**Re: Headquarters Road over Tincum Creek Replacement Project
Permit No. E0901120-026, Pennsylvania Department of Transportation**

The Delaware Riverkeeper Network and Maya van Rossum, the Delaware Riverkeeper, submit the following comment in opposition to the Joint Permit Application (“Application”) submitted by Pennsylvania Department of Transportation (“PennDOT”) Engineering District 06. PennDOT proposes to demolish the historically invaluable Headquarters Road Bridge (also known as Sheephole Bridge or Burnt Mill Bridge) along Tincum Creek located in the Ridge Valley Rural Historic District in Tincum Township, Bucks County, and construct a modern two-lane bridge in its place (hereinafter, the “Project”).

Figure 3. HEC-RAS Cross-section locations.

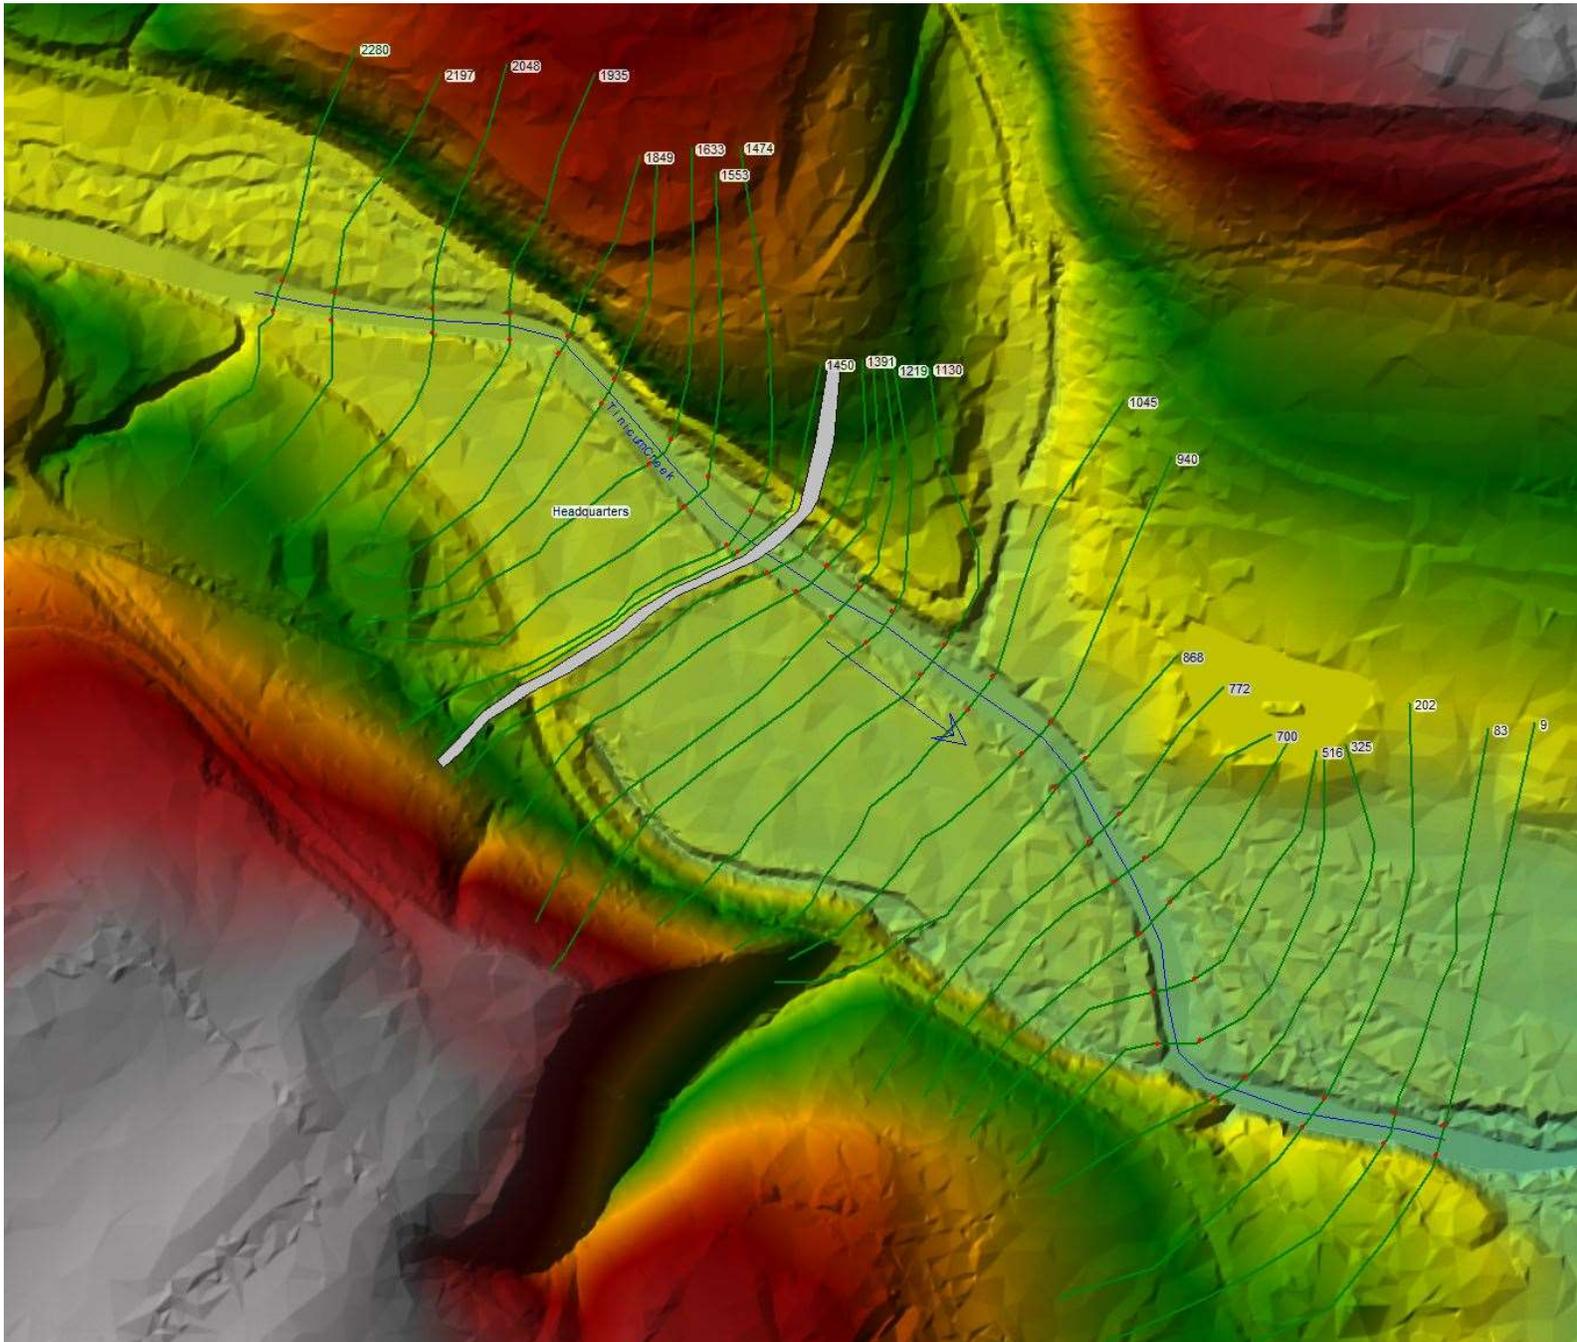
Figure 3 below depicts the cross-section locations modeled by RWE. The cross-sections are numbered measured based on the distance from the downstream end of the Tincum Creek reach

modeled starting with Station 9 and ending with Station 2280. The Headquarters bridge is shown in grey in the center of the figure. The cross-sections shown were established using LiDAR data available for the project area in combination with the data obtained from DRN for the project. The cross-sections are generally spaced every 100 feet with more cross-sections in areas where the channel geometry varies and around the bridge itself.

Slide 1: Stabilization Plan (original)

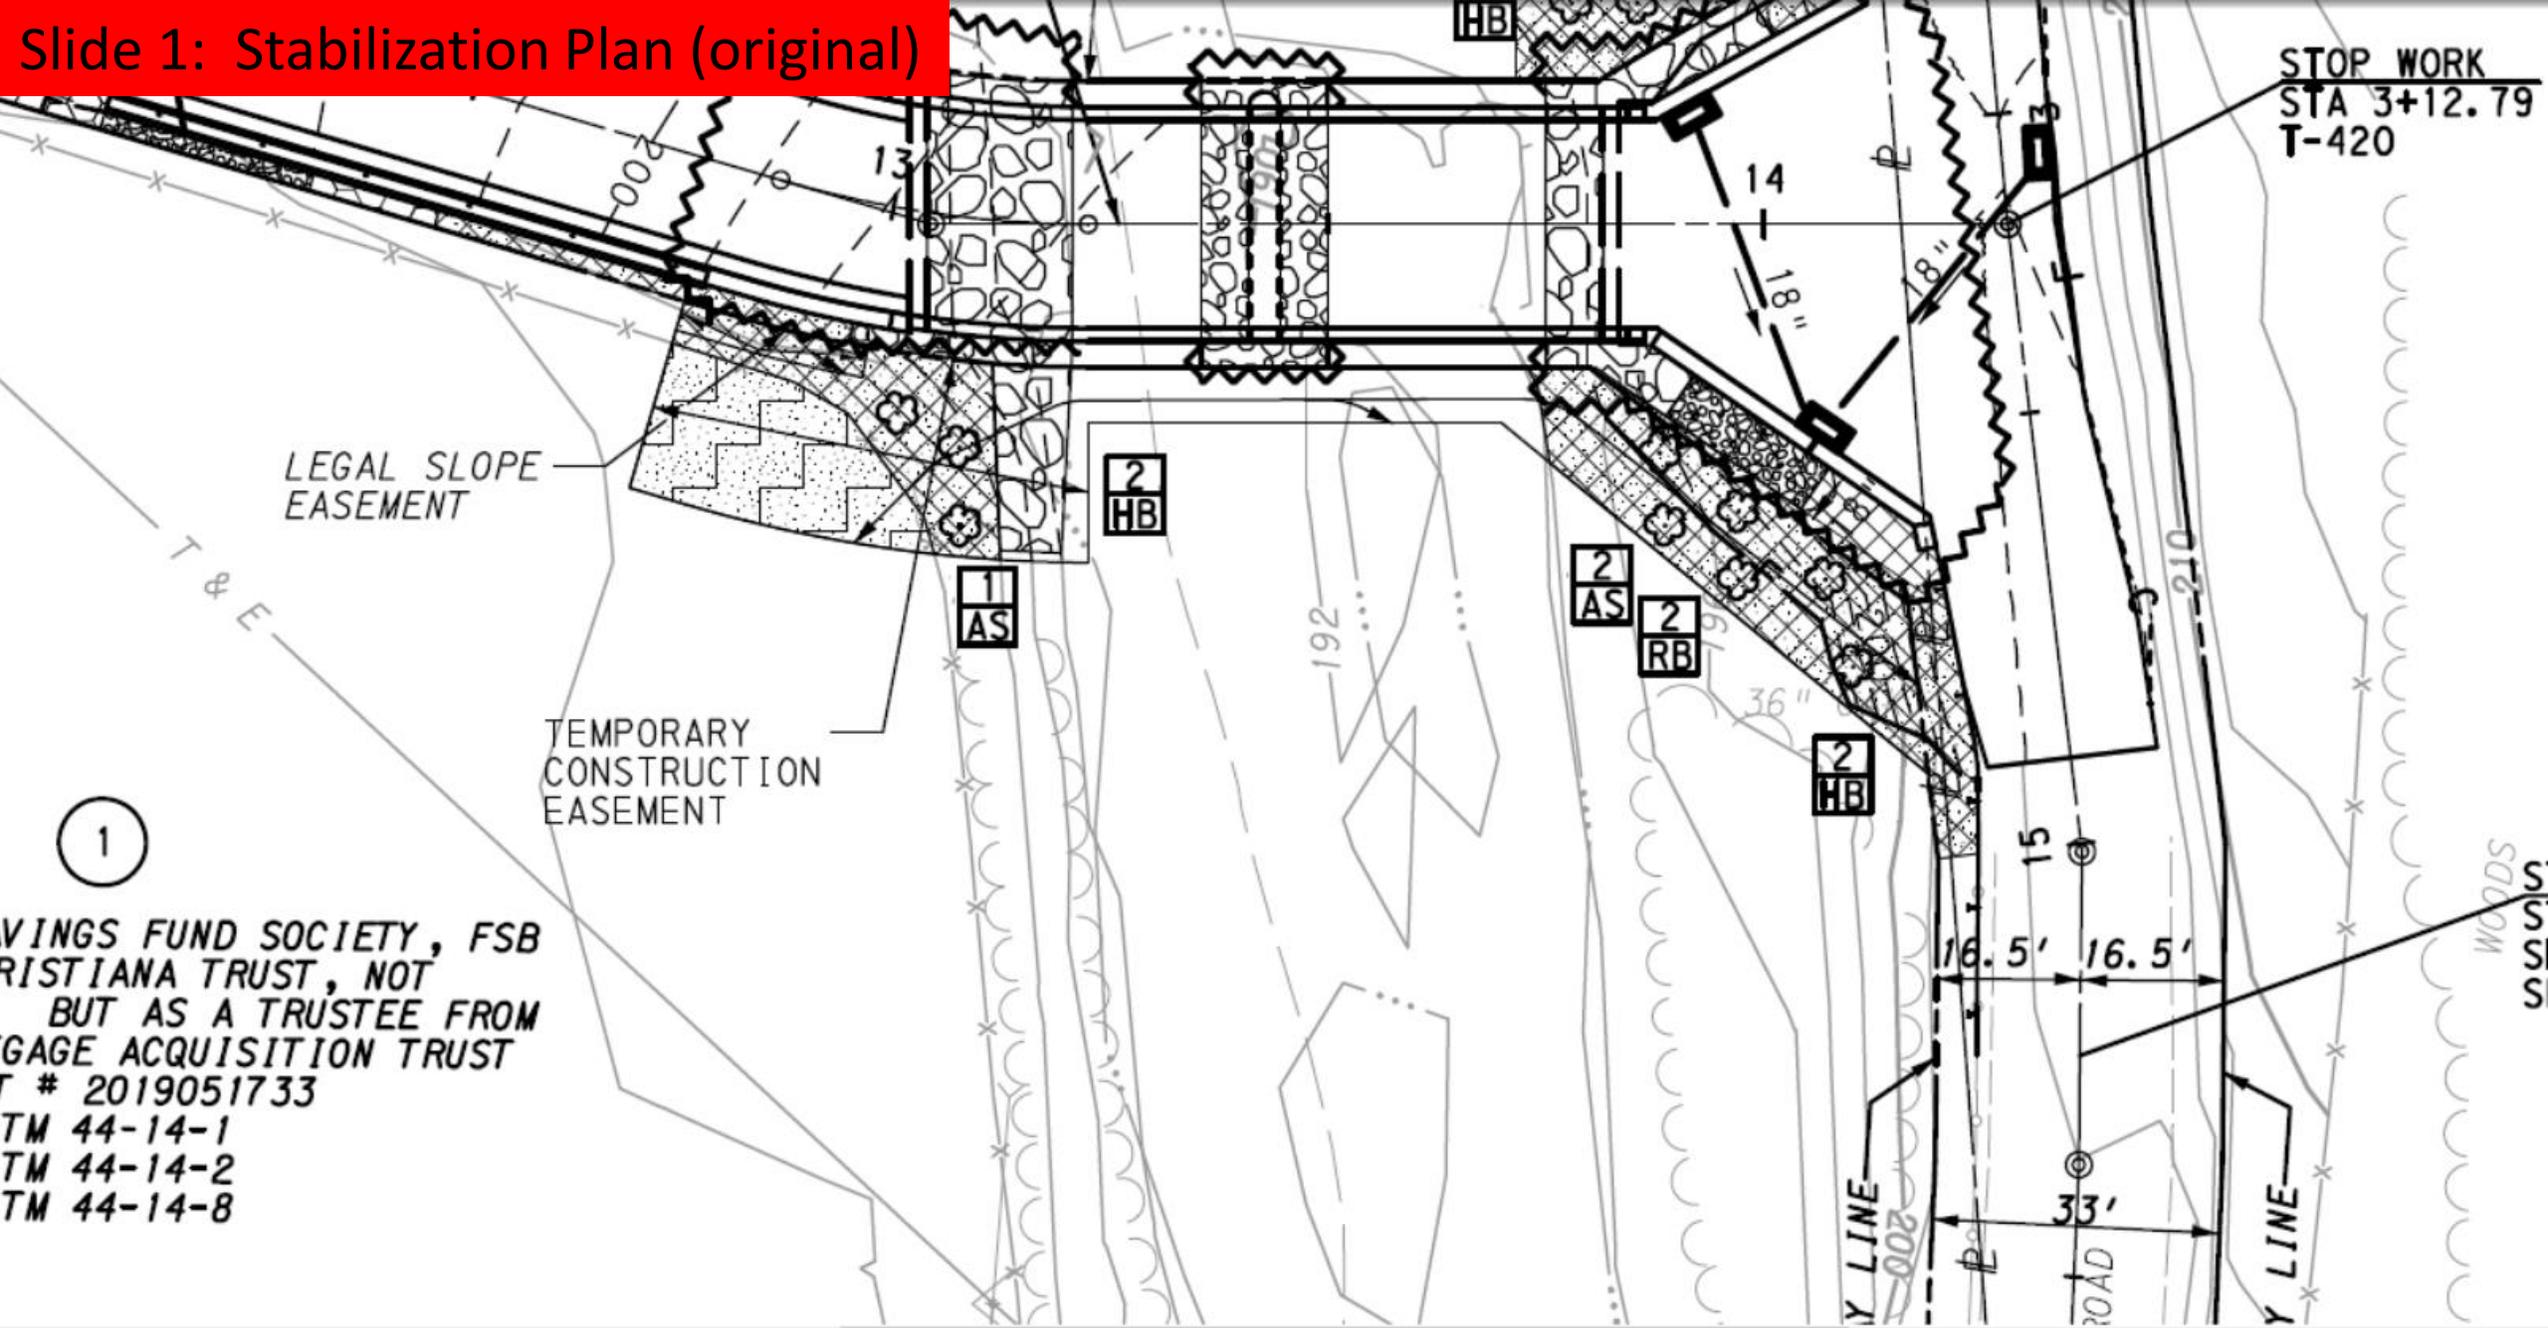
zoom in on "Stabilization Plan" (sheet 11 of 11)

Slide 2: Stabilization Plan with notes

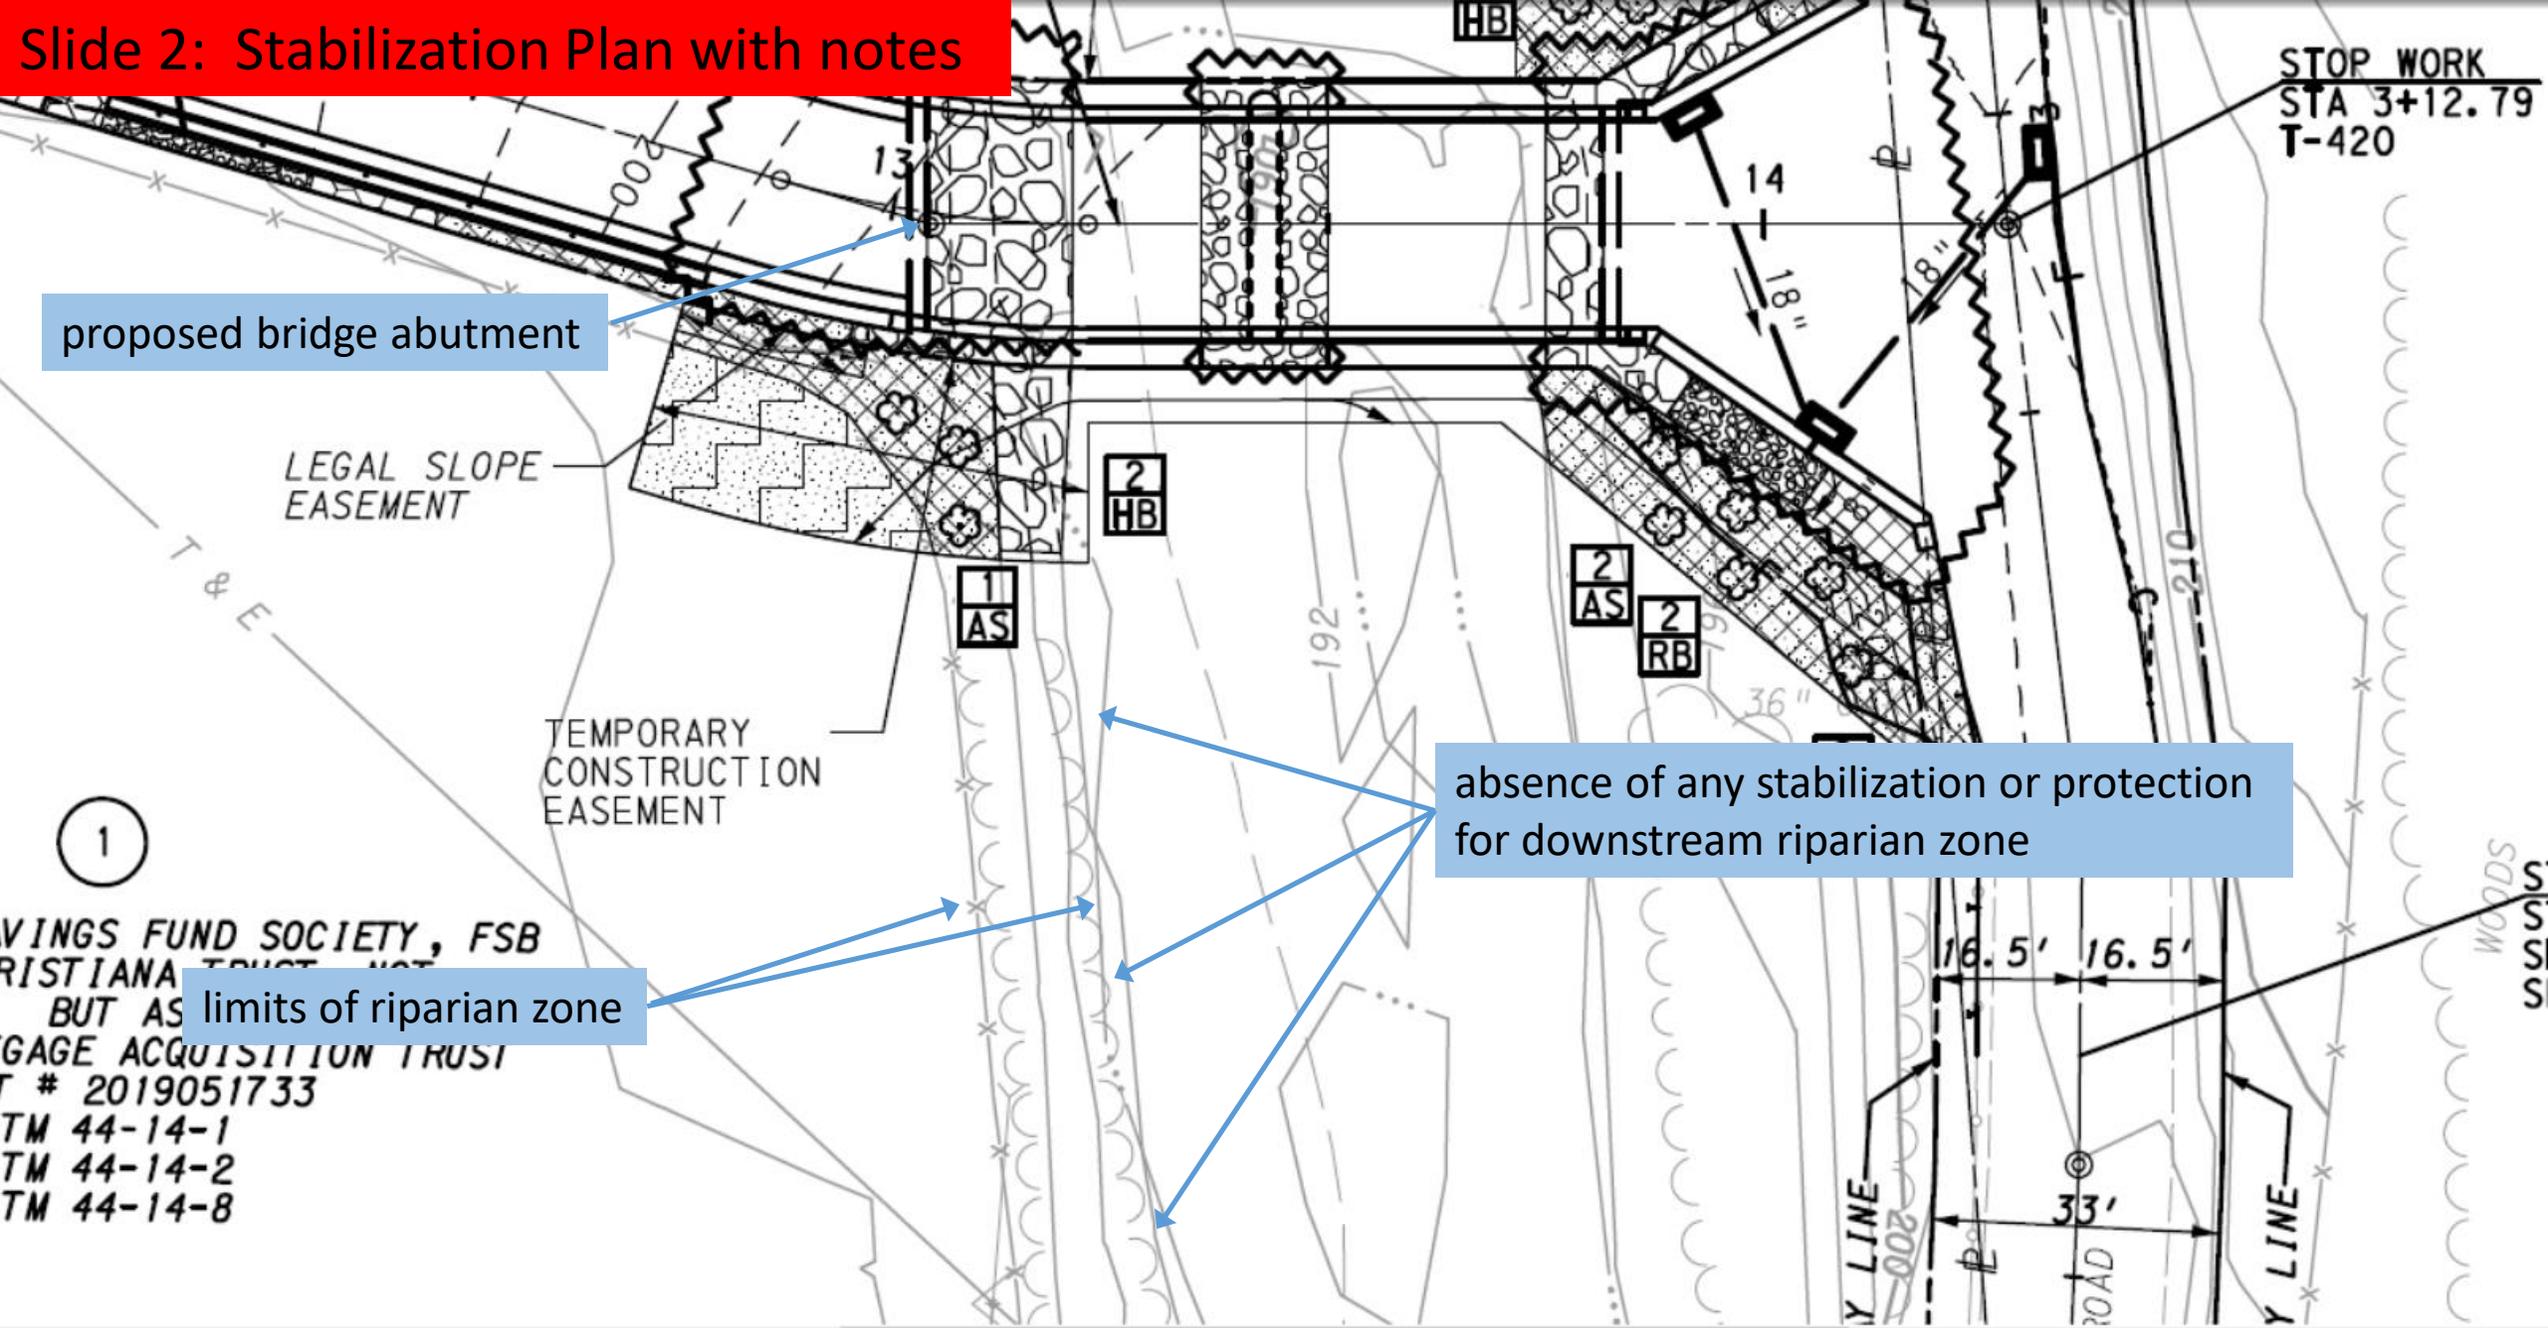
proposed bridge abutment
